Subject: Kilarc-Cow Creek Project (FERC Project No. 606)

Response to FERC Additional Information Request in Letter dated September 3, 2009

Response to AIR

Figure 1. Regional Groundwater Basin and Old Cow Creek above the Kilarc Diversion Dam Watershed

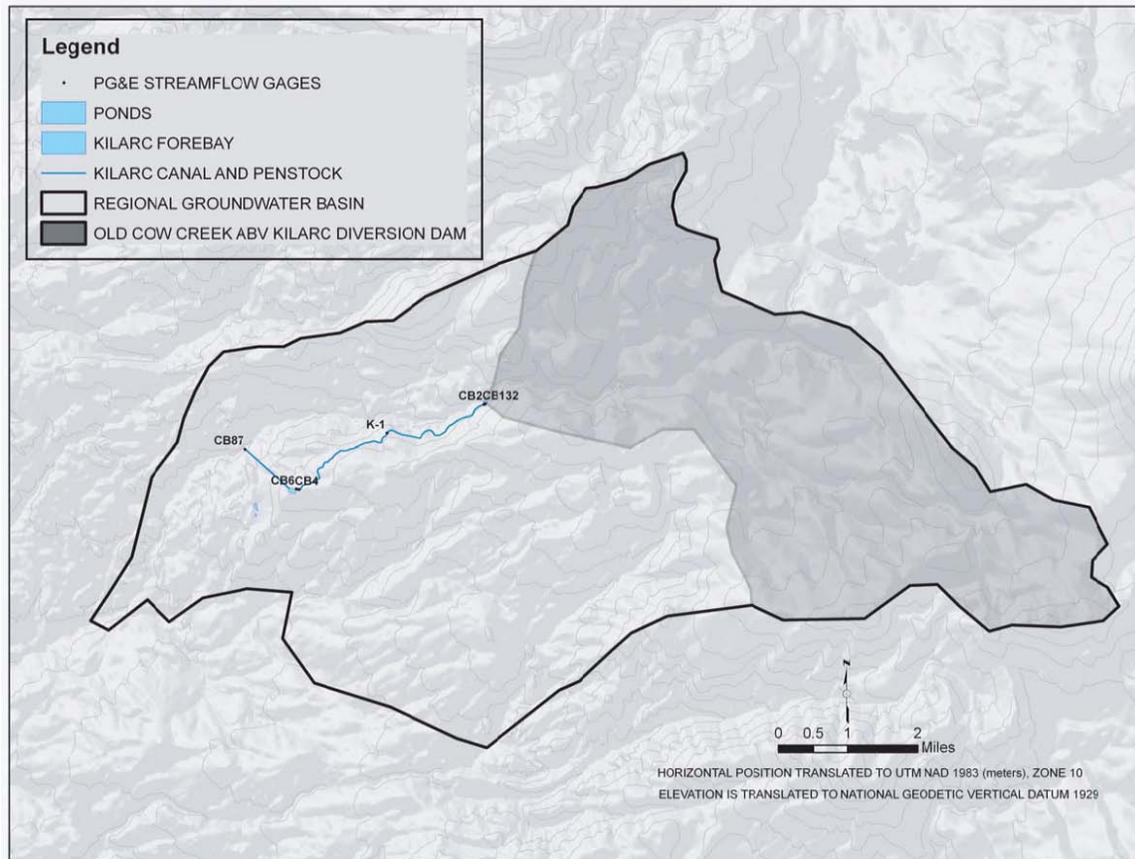
Water Resources Item 4: Please provide information, including any available data, regarding the hydrogeology and groundwater resources in the project area that might be reasonably influenced by the Kilarc forebay. Please discuss the potential impacts of dewatering the Kilarc forebay on local groundwater resources.

The regional groundwater basin consists of 39,715 acres that range from approximately 2,000 feet to 5,200 feet above mean sea level (MSL) as shown on Figure 1. The aerial extent of the regional groundwater basin boundaries were determined by delineating the topographic divides between adjacent watersheds. The groundwater basin was assumed to be coincident with the topographic drainage basin.

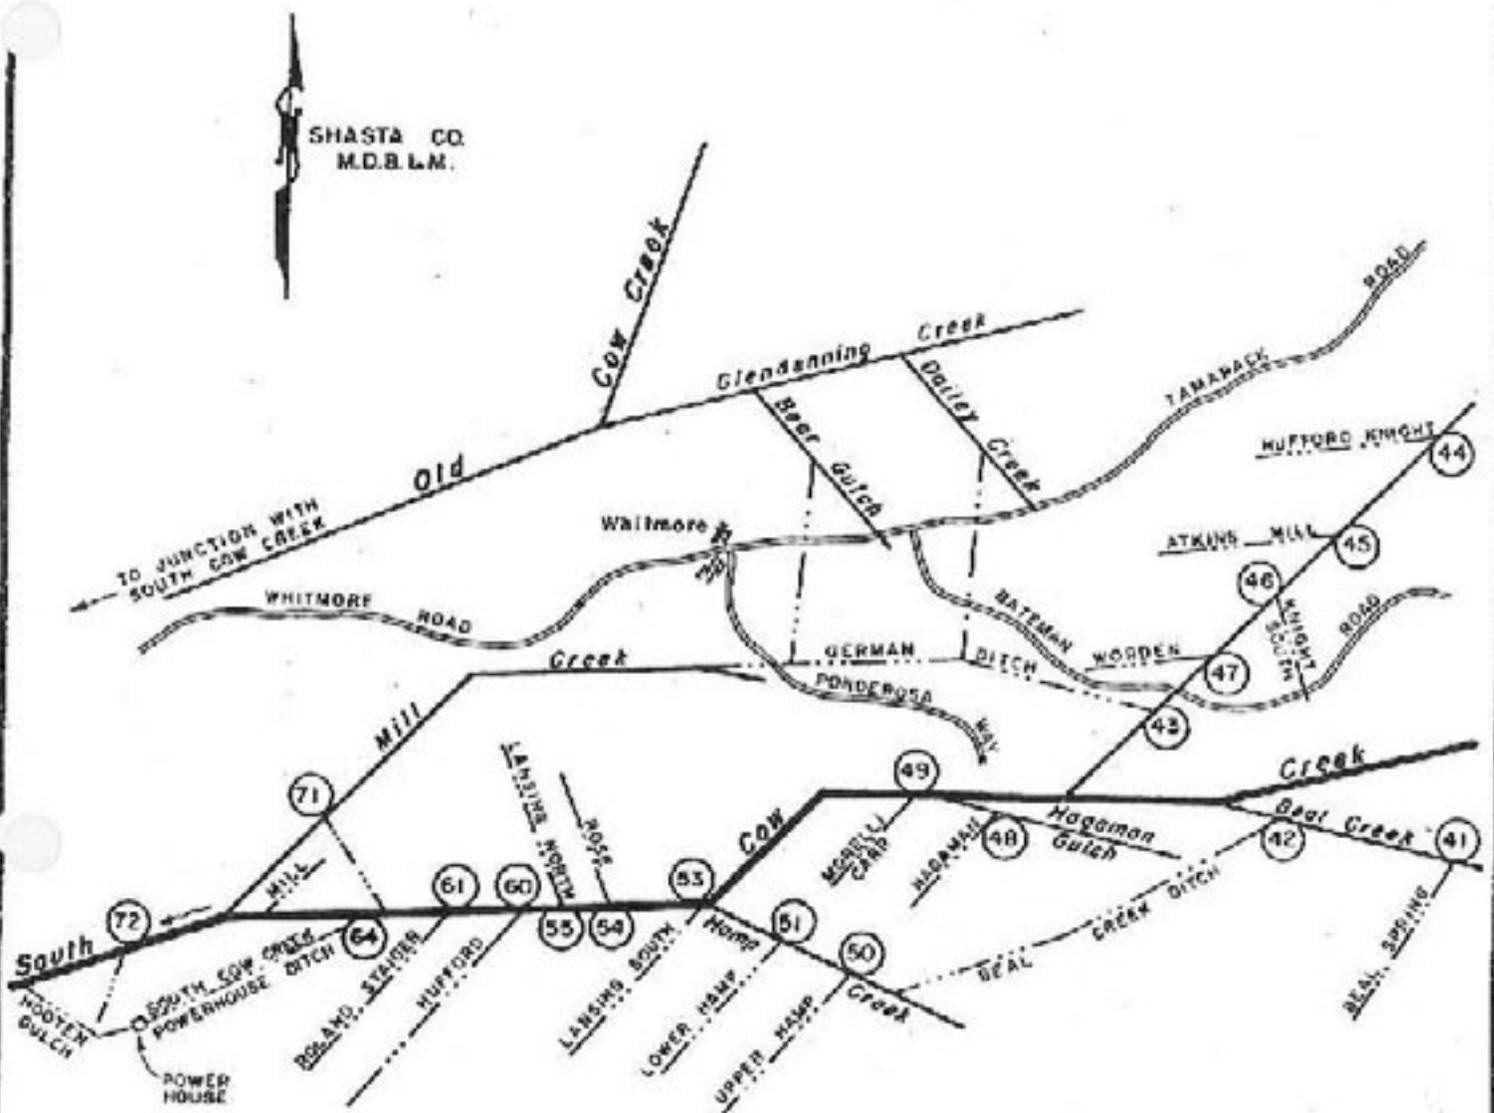
We agreed that this is probably a barrier to all species at all flows.

Attached are the pics from today and one from low flow (#643).
